August 5, 2019

Product Change Notice - New screws for screen door catches

Fig.1

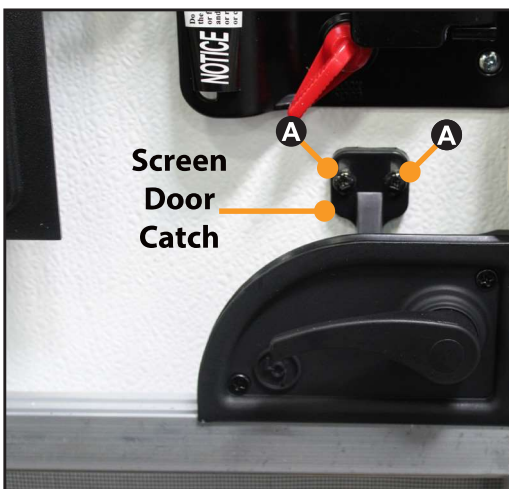
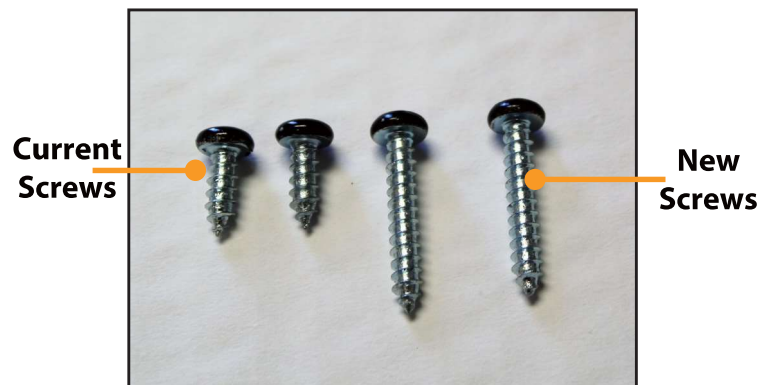
Please be advised we are changing the length of our screen door catch screws (Fig. 1A) from # 8 - 15 X 1/2 Square Pan Head to #8 X 1 Square Pan Head (Fig. 2).

The new screw has more threads for better thread engagement. The new, longer screw also makes adjusting the catch easier if needed.

There is no change in fit, form or function with the new screws. The current screw part number is 328275 and the new screw part number is 227619. The overall assembly number for the door does not change, nor does the part number for the screen door catch.
